2	-		-
1	ISSUED FOR REVISION - ADDENDUM #1	CEA	JUNE 24 2025
0	ISSUED FOR CONSTRUCTION	CEA	MAY 6 2025
No.	REVISION/DESCRIPTION	BY	DATE

PROJECT
FLEET MANAGEMENT OFFICES
WASHROOM RENOVATIONS

PARTIAL MAIN FLOOR PLAN
DEMOLITION & RENOVATION

SCALE	PROJECT No:	SHEET No:
AS SHOWN	2024-119	A1

2 WASHROOM RENOVATION PLAN
1/4" = 1'-0"

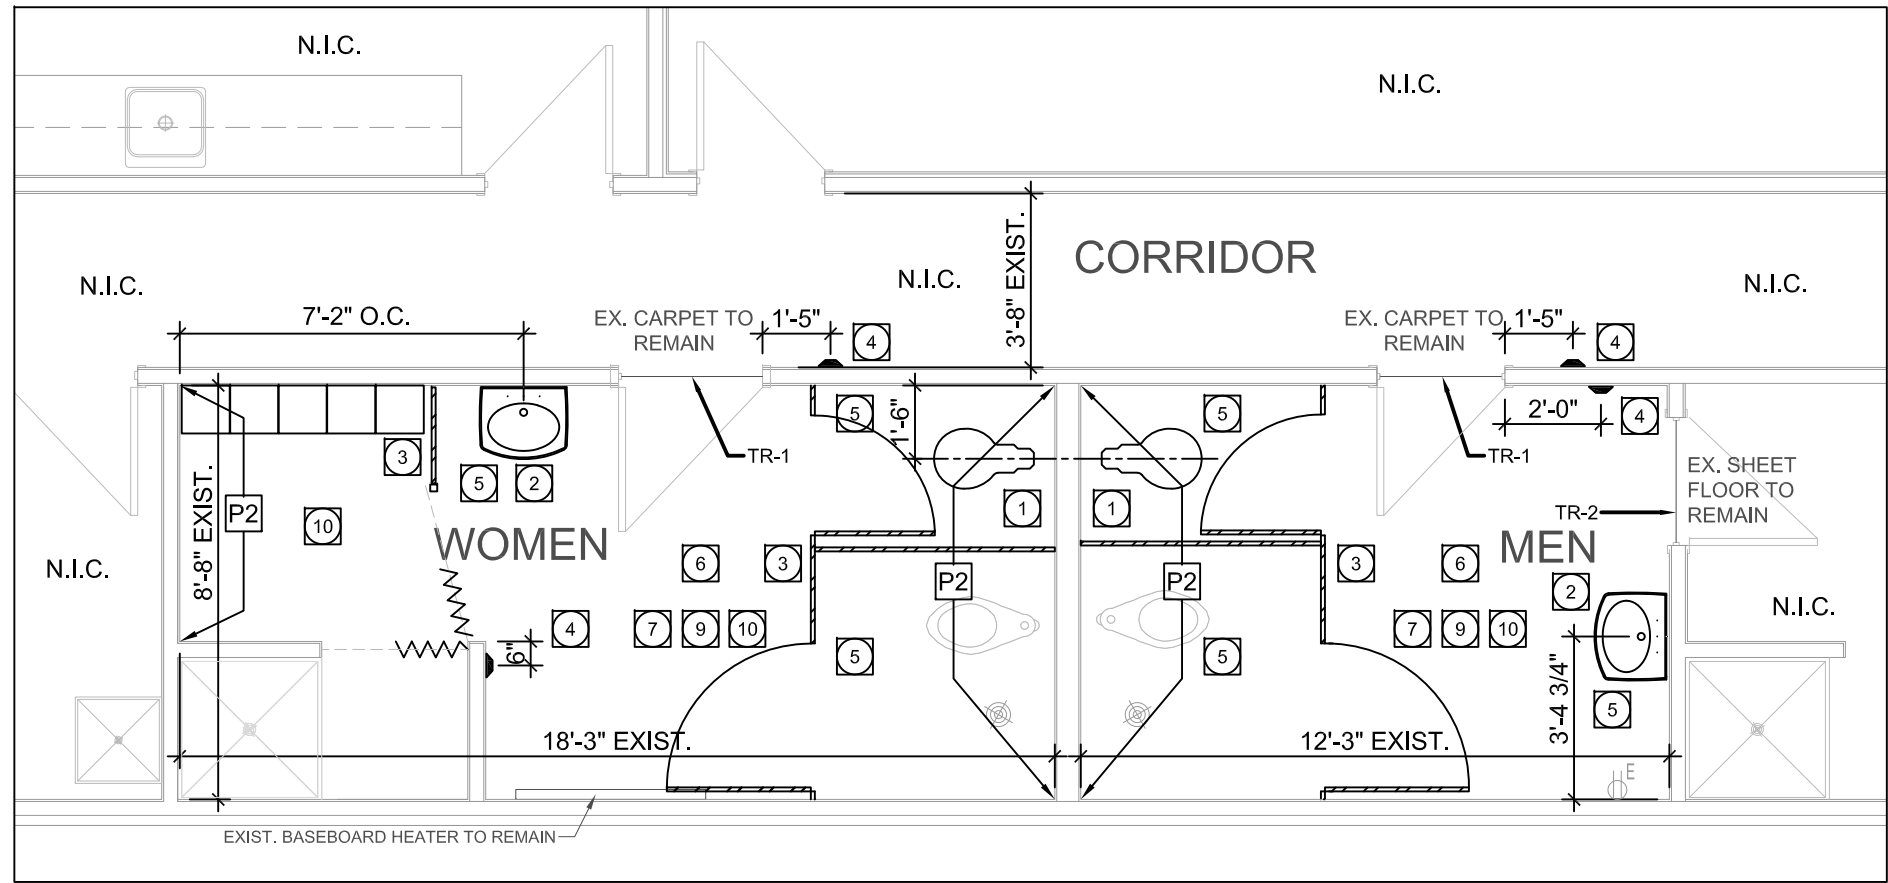
ADDENDUM #1
ACCEPTABLE EQUAL FOR AUTO DOOR
OPERATOR: ASSA ABLOY, BESAM SW200I
